Kodak DryView
8900 LASER IMAGER

Service Bulletins

Part Discontinued - ROLLBACK FLAG/GEAR

Front view of PANEL INSERT

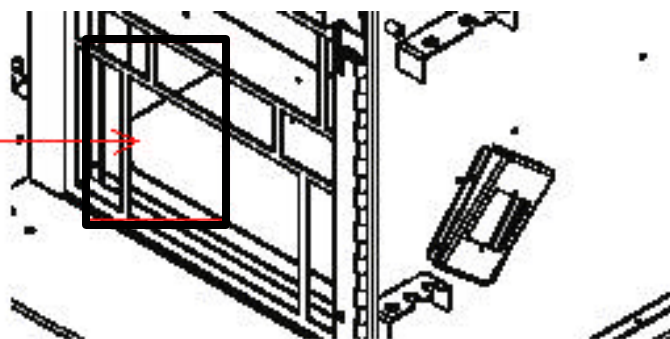
When an old style POWER MODULE is to be replaced with a new style POWER MODULE it will be necessary to install a small PANEL INSERT to accommodate the smaller design of the new POWER MODULE. The part number for this PANEL INSERT is SP8E4896.

1. Apply 2-sided TAPE to the back sides of the PANEL INSERT as indicated by the arrows.
2. Remove the old style POWER MODULE.
3. Place the PANEL INSERT on the left side of the FAN opening (highlighted by the box).
4. Install the new style POWER MODULE.

Old POWER MODULE – Bad UPS Workaround

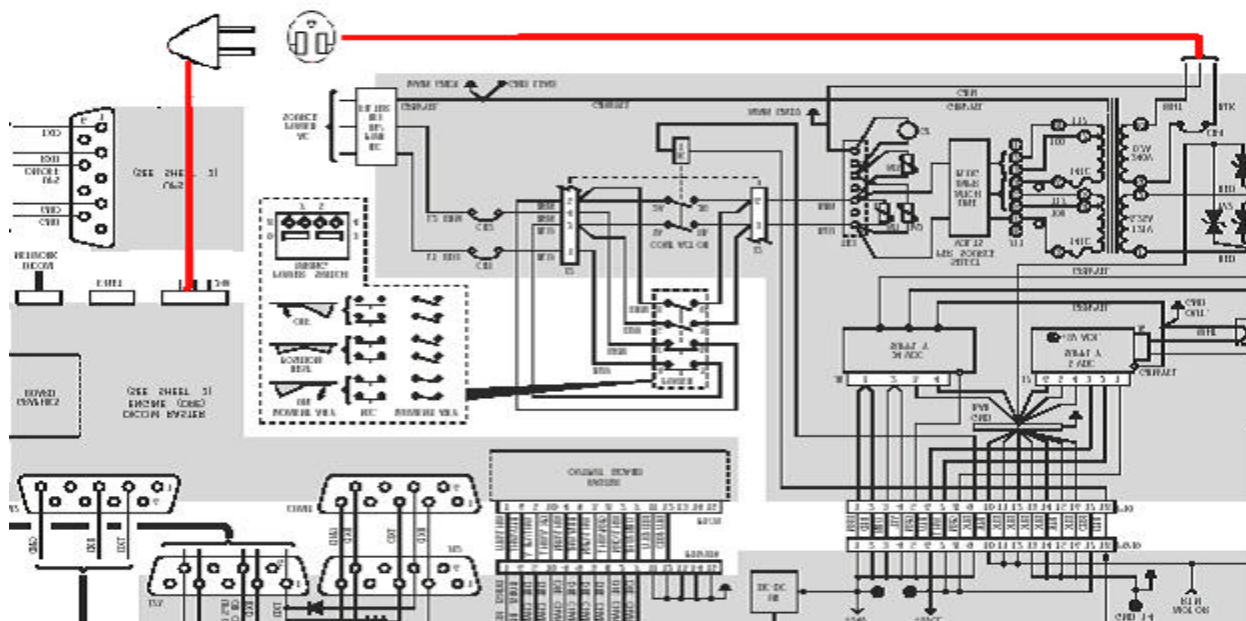
Several POWER MODULE assemblies have been replaced in the field due to a failed UPS. With Release 2.11 software installed the UPS is no longer needed. The main purpose of the UPS was to perform a controlled shutdown of the DRE. Development has determined that with Release 2.11 software this controlled shutdown is not necessary, eliminating the need for the UPS.

1. Verify the EBA BOARD (SP8E1593) is at revision G or higher. If the EBA BOARD is a prior revision the system will not remain in the ON state because it requires communication with the UPS in order to hold the system energized.
2. Verify that the 8900 LASER IMAGER has been upgraded to at least Release 2.11 software.
3. Divert power from the UPS by disconnecting the incoming line voltage from the secondary windings that feed the UPS and connect it directly to the POWER CORD that feeds the DRE as depicted in the drawing below.

The POWER CORD from the DRE can plug directly into the LINE CORD from the secondary tap of the POWER MODULE TRANSFORMER.

Flex Duct – Processor Air Duct Improvement

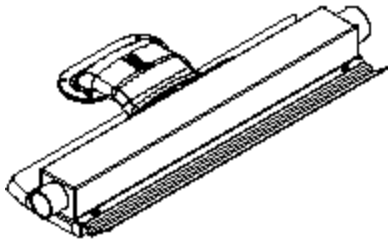
Mechanical design has made a product enhancement to the Air Duct on the Thermal Processor Assembly. The modification increases the airflow through the Processor and assists in removing more of the FAZ from the Thermal Processor assembly. Below is an image of the new Duct.

Machines with S/Ns before 890002670 can be modified to include the Flex Duct. The main components of the new Flex Duct are as follows:

Bearing Redesign

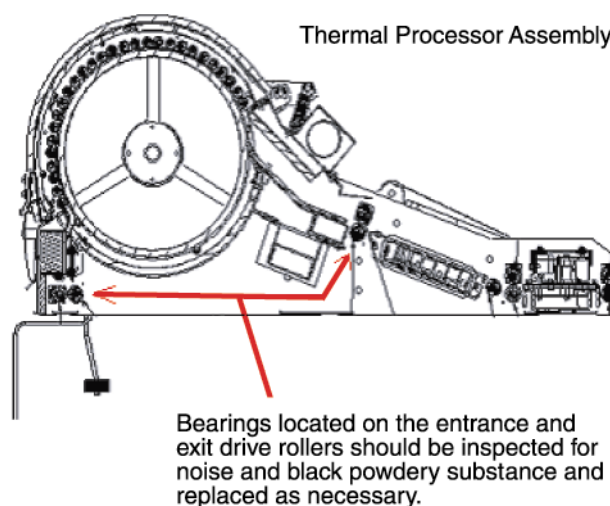
Be advised that Design has identified and Field Service has verified the potential of a premature bearing failure in the *Kodak DryView 8900 LASER IMAGER*. The identified bearing (Part Number SP6E8804) is used throughout the machine; but to date, the failure has been isolated to two locations in the Thermal Processor Assembly as identified in the image below. These locations are introduced to small amounts of FAZ, operate at a slightly higher temperature, and operate at a higher radial load due to the drive train.

Symptoms of a failing bearing are deposits of a black powdery substance below the affected bearing (see image below) and/or a high frequency noise emanating from the Thermal Processor Assembly.

A new bearing design has been implemented (changed lubricant) and is available in Spares (Part Number SP5F2063). On a next call basis, close inspection of all bearings in the Thermal Processor Assembly) is advisable. Machine Serial Number effectivity for the use of the new bearing design is 890002262. A minimum quantity of five of the new bearings should be maintained in all field service custody.
